**PLEASANT PRAIRIE PLAN COMMISSION MEETING
VILLAGE HALL AUDITORIUM
9915 39th AVENUE
PLEASANT PRAIRIE, WISCONSIN
6:00 P.M.
April 17, 2018
AGENDA**

VILLAGE STAFF REPORT OF APRIL 17, 2018

SUBJ: Haribo of America – Concept Plan

VOPP ENG REVIEW PLAN-MARK UP MARCH 12, 2018

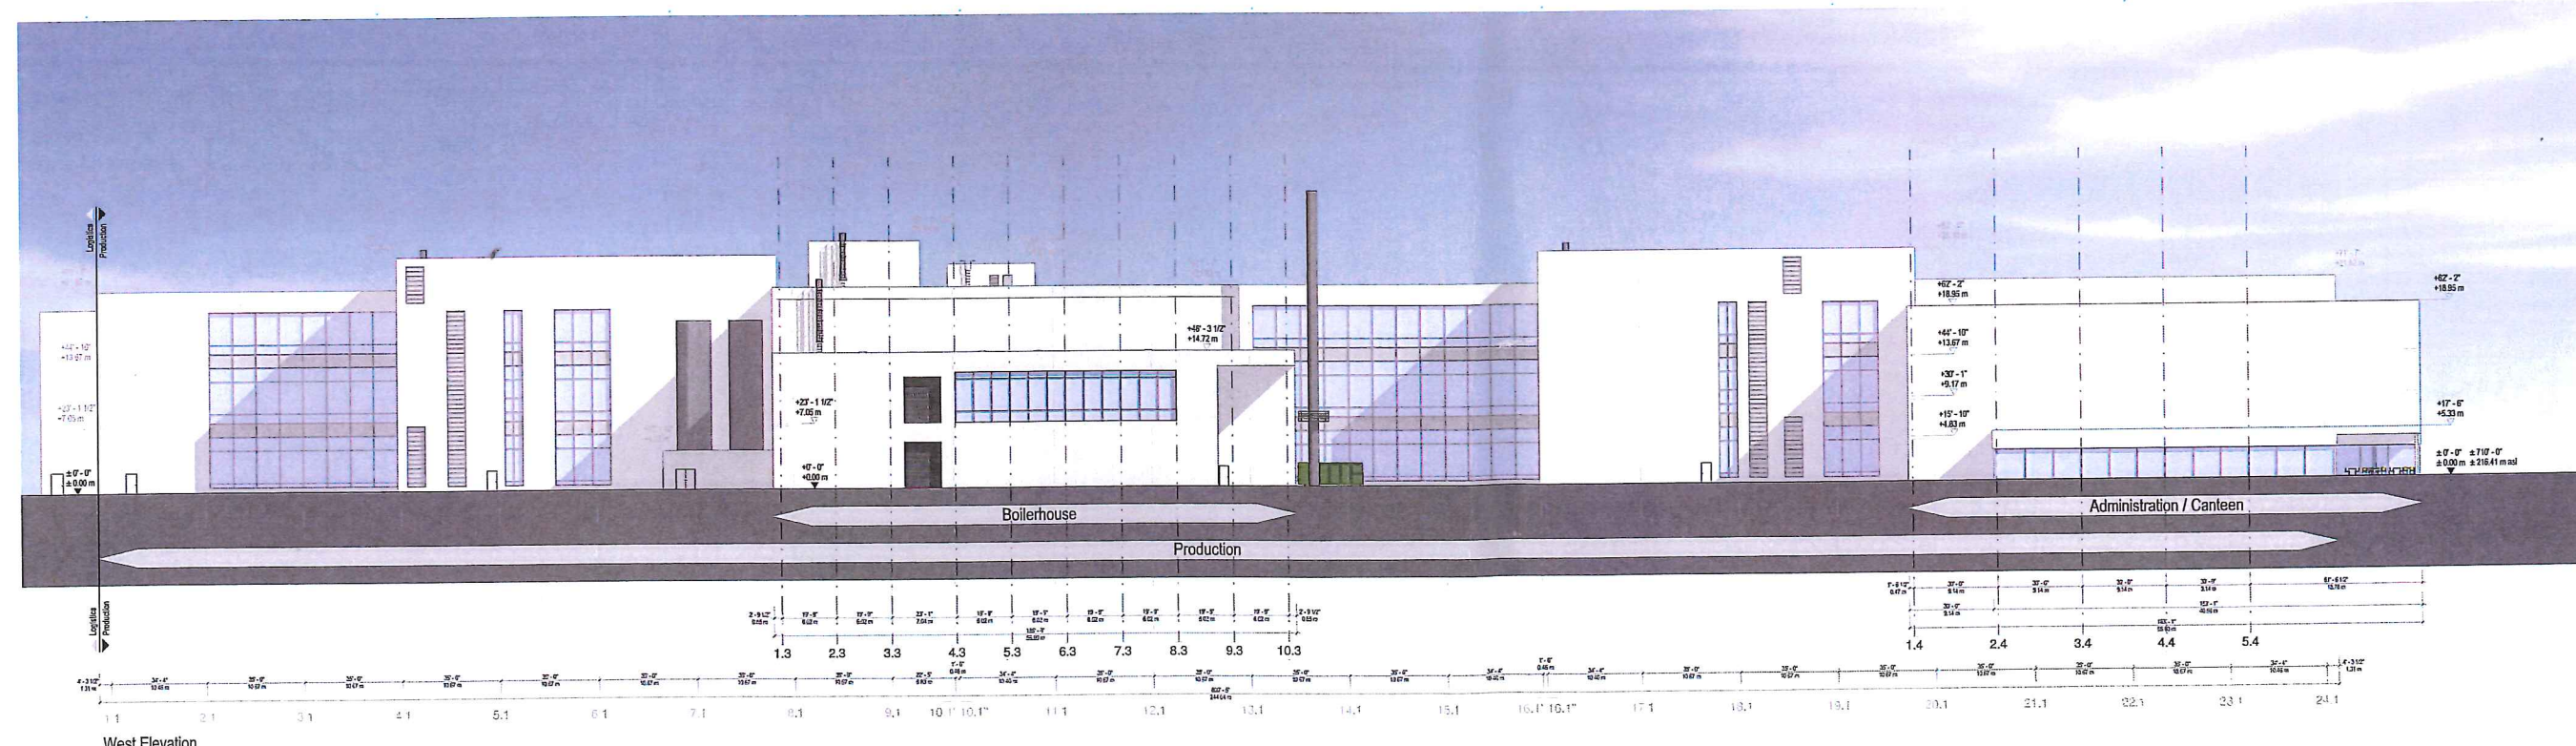
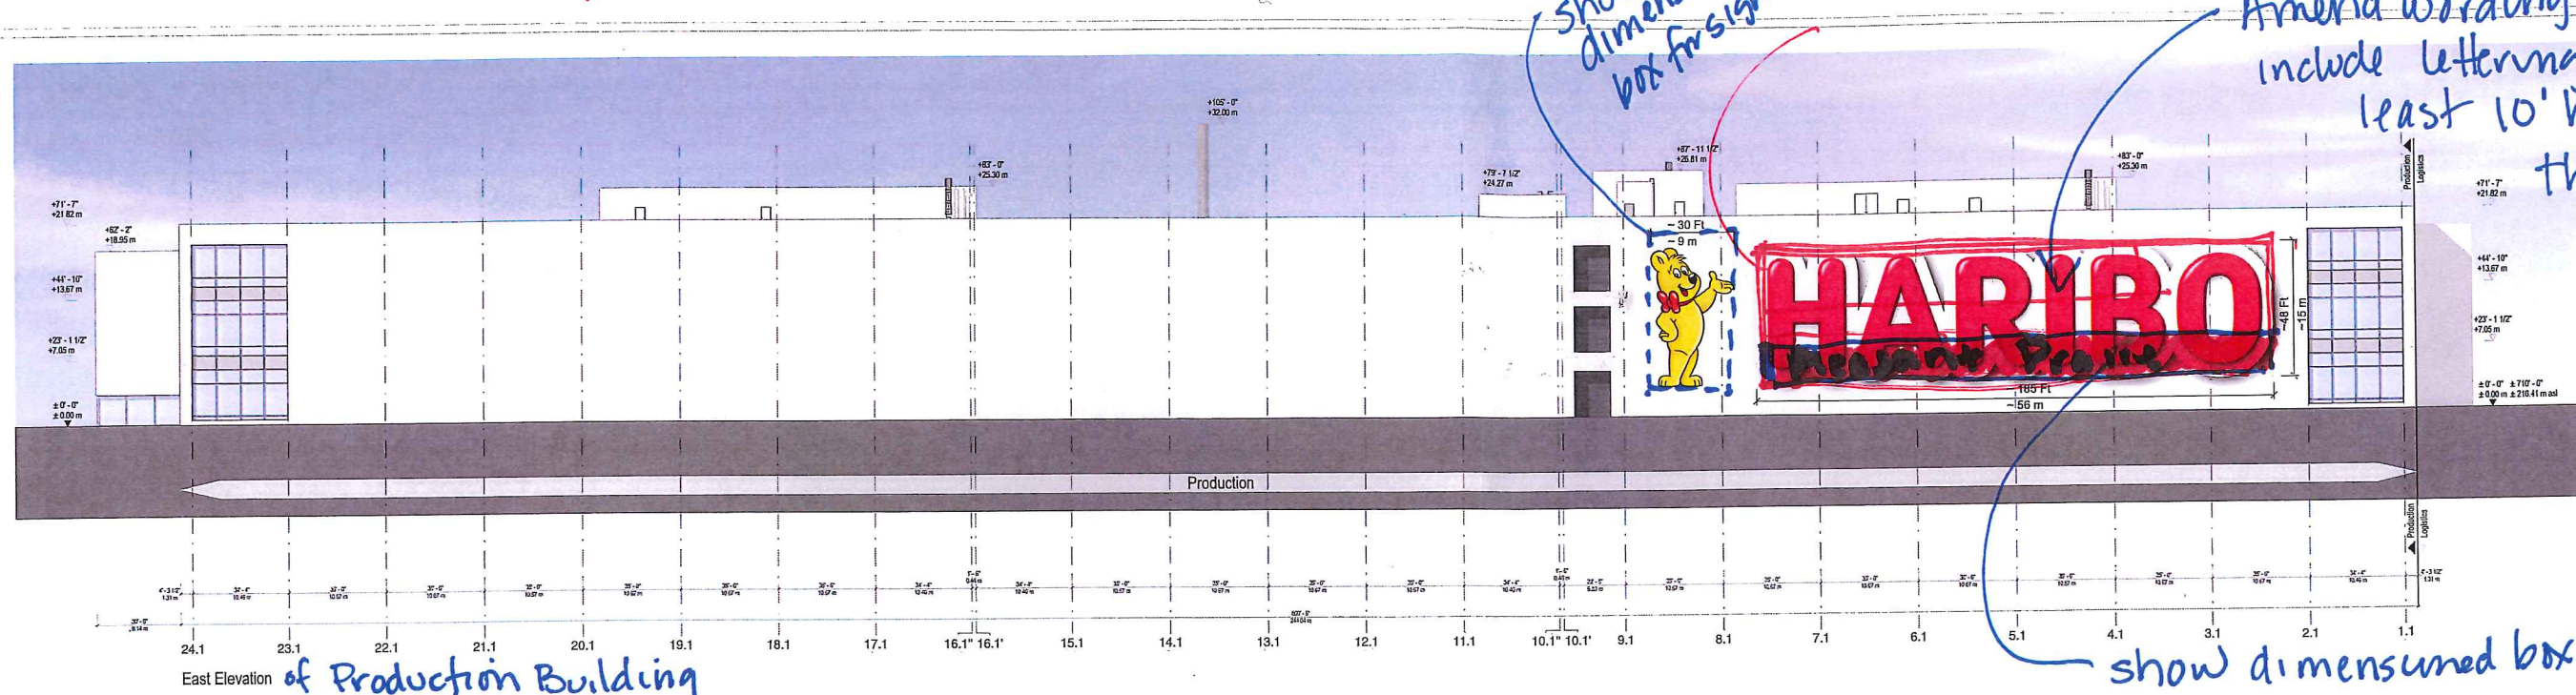
Provide revised exhibit to use As exhibit
B in POD

show dimension box for sign area

- show dimensioned box for step area

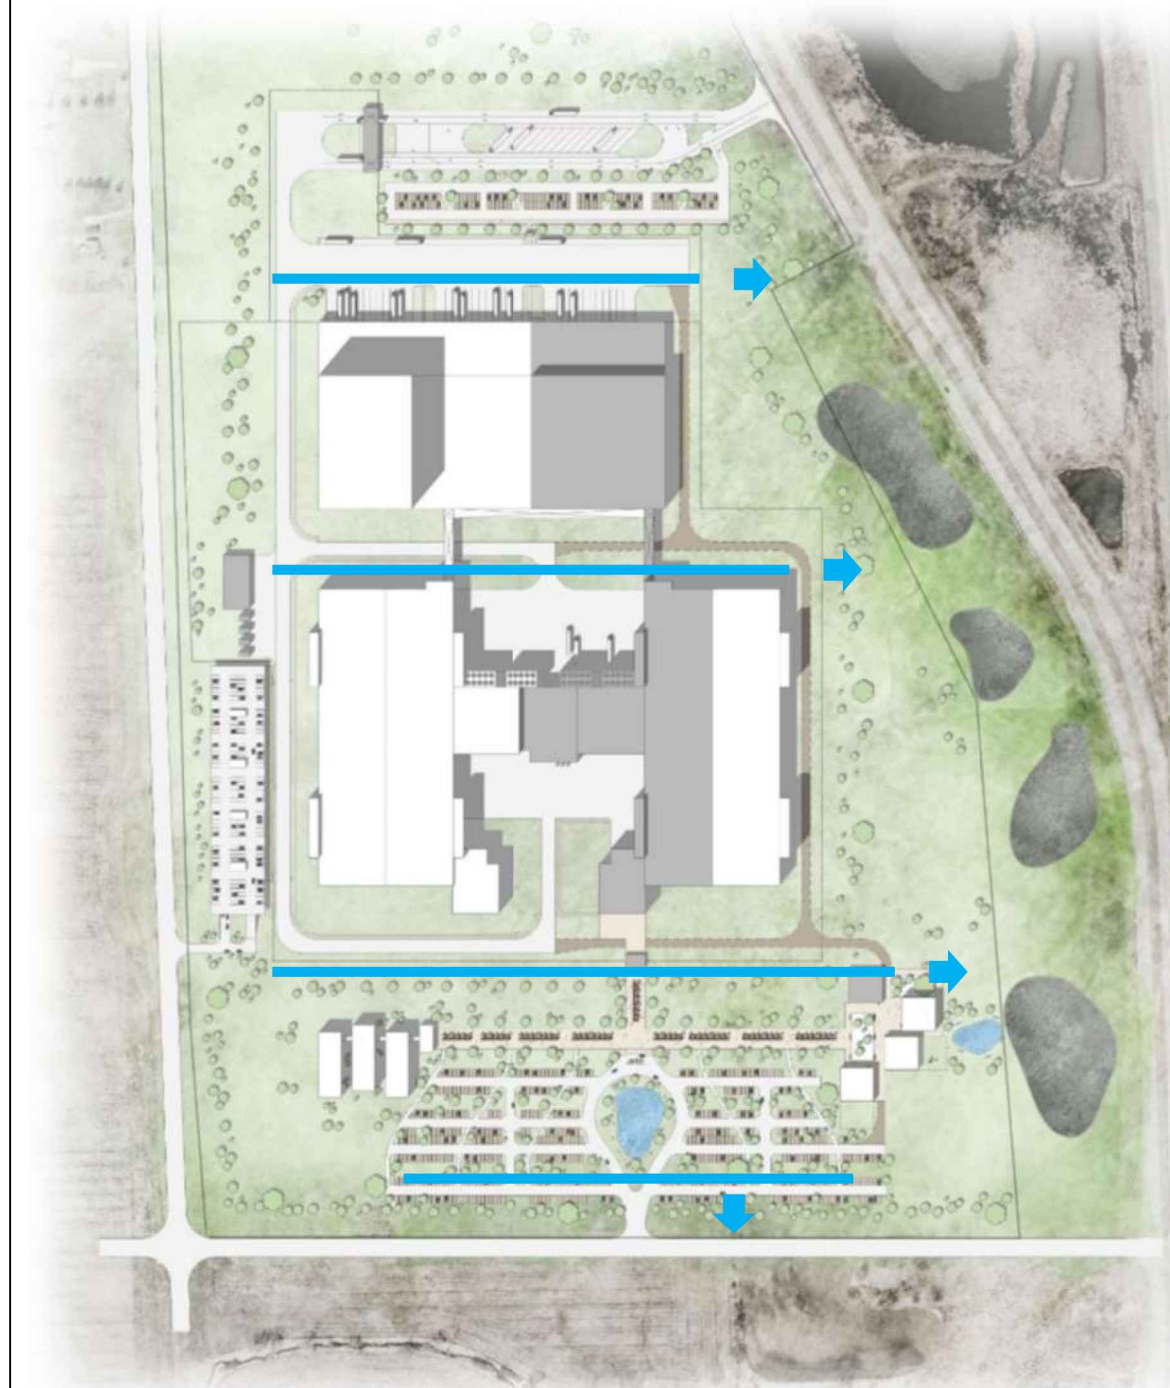
CONCEPT PLANS DO NOT SHOW THIS DRIVE IN
PHASE 1 - COORDINATE WITH FIRE
DEPARTMENT REGARDING FIRE ACCESS DRIVE
REQUIRMENTS FOR BUILDOUT AND
DEVELOPMENT PHASES- RECTIFY ALL
DESCREANCIES BETWEEN PLANS AND
DEPICTION

WHAT IS THIS...PLANS
SHOW FUTURE
MULTISTORY CAR
PARK BUT NOTHING
FOR PHASE 1

SOUTH ROAD
(GOLDBEAR DRIVE)
WILL BE A BOULEVARD

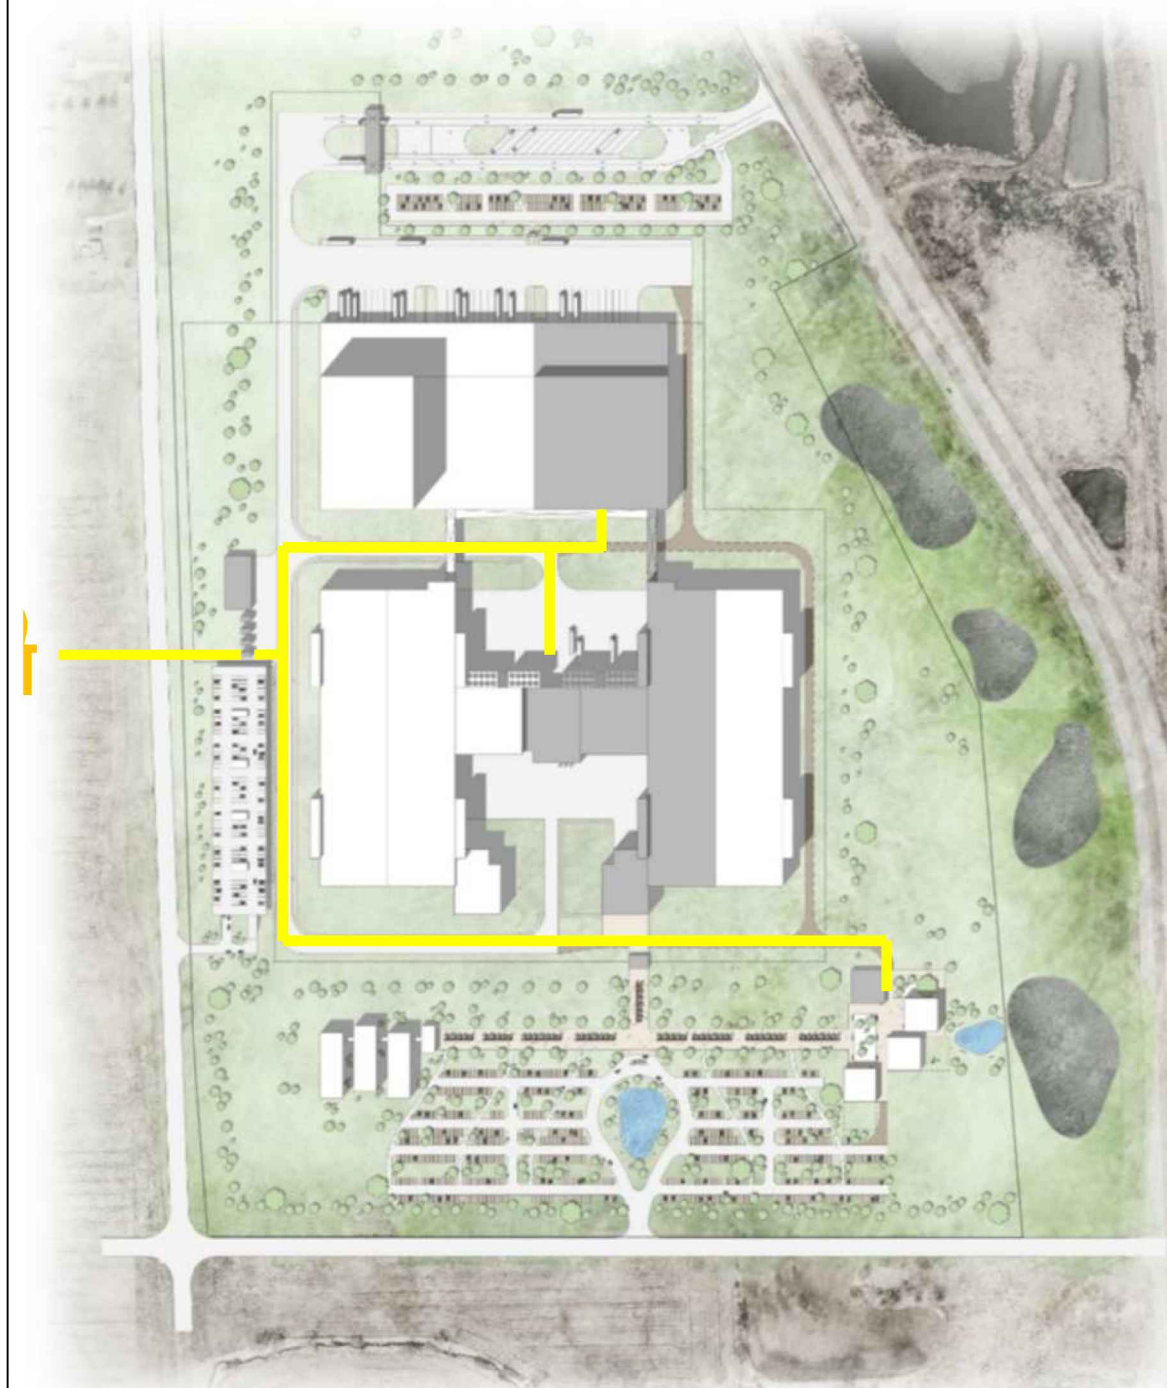
HARIBO TO COORDINATE WITH WE-ENERGIES

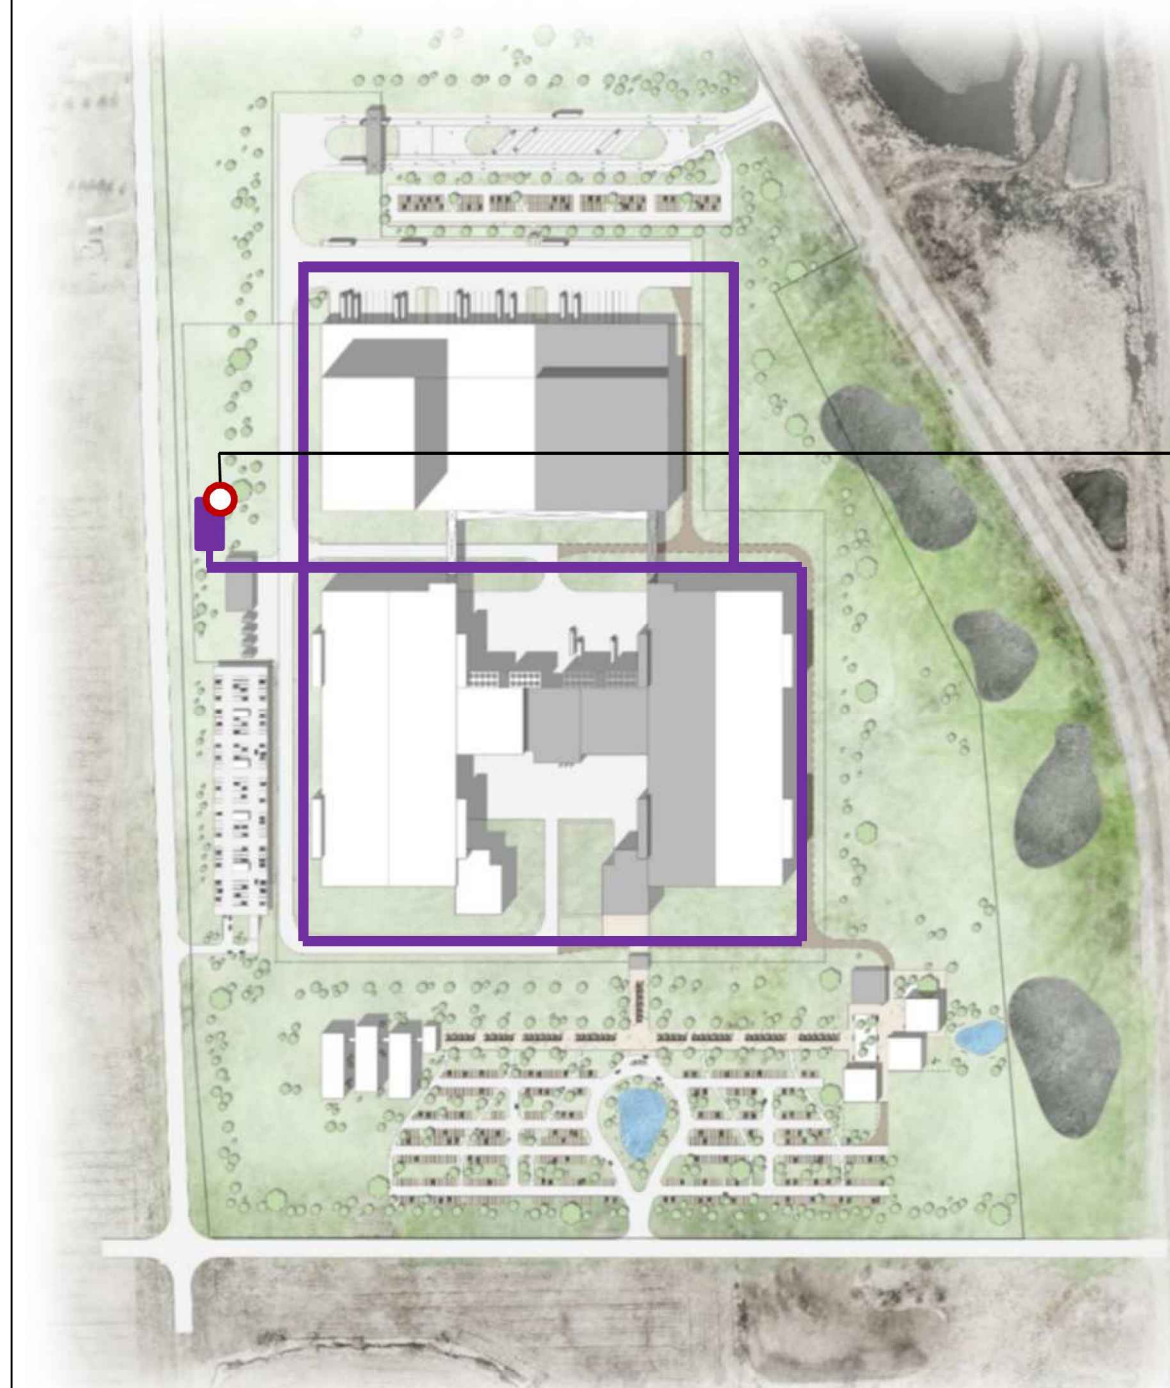
PROVIDE INFORMATION...IS THIS IN A BUILDING? THIS WILL NEED TO BE DISCUSSED WITH COMMUNITY DEVELOPMENT

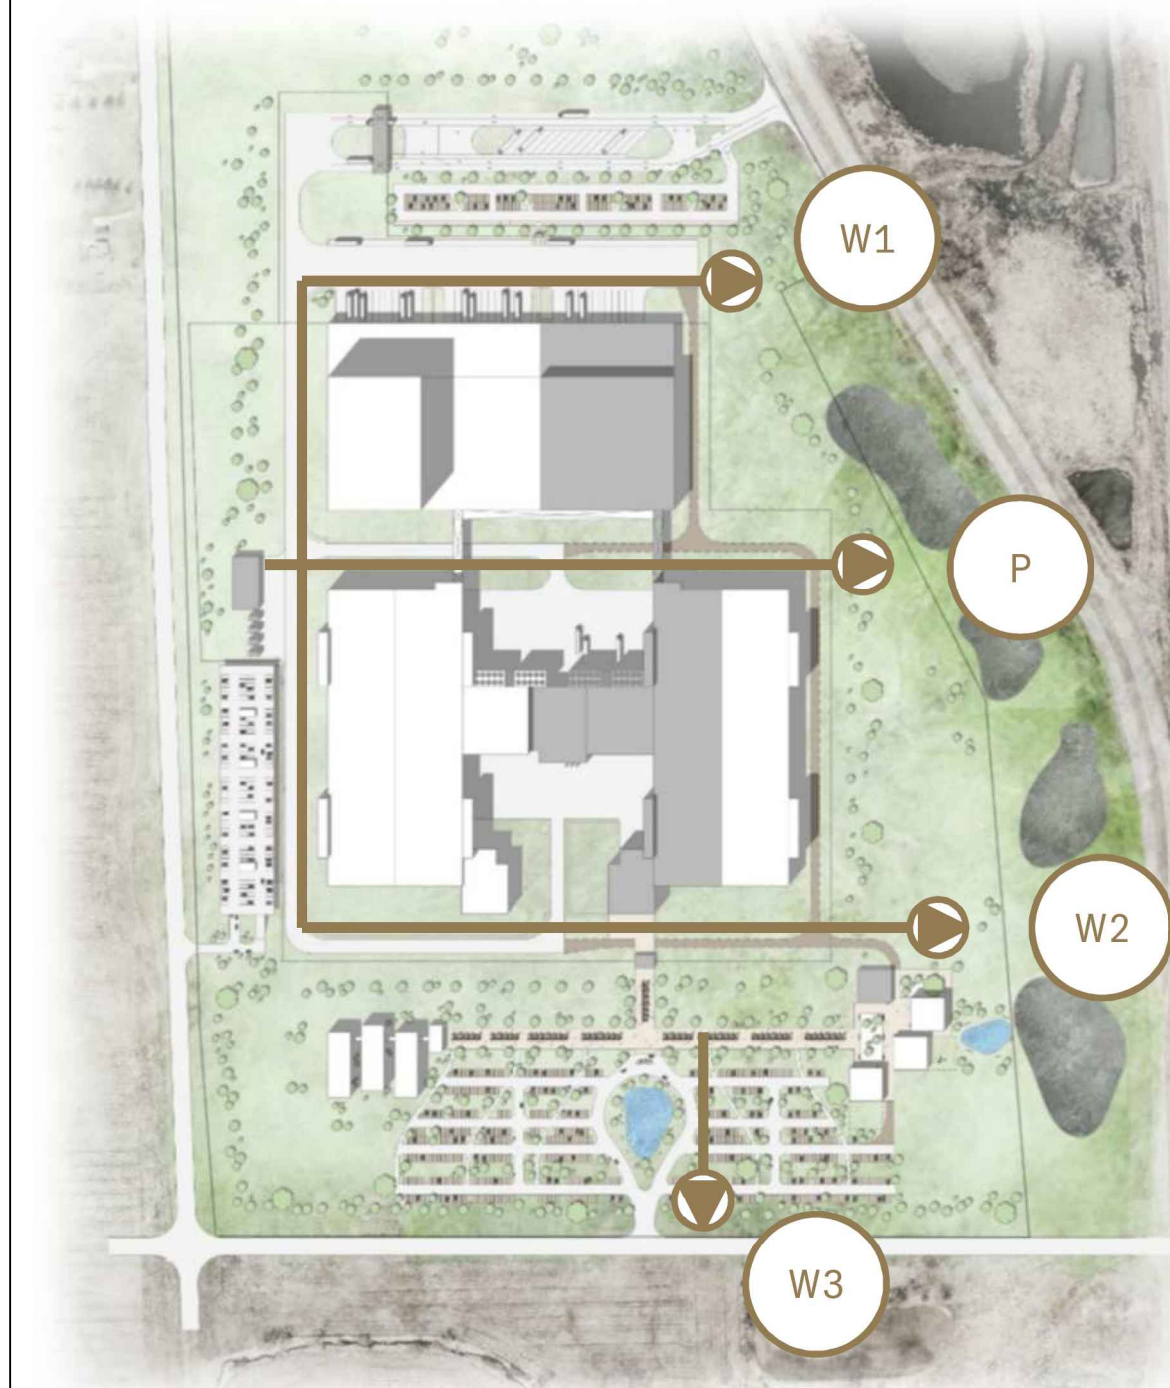
PROVIDE PRELIMINARY
UTILITY LAYOUT
— PLAN....THIS DOES NOT
APPEAR DESIRABLE
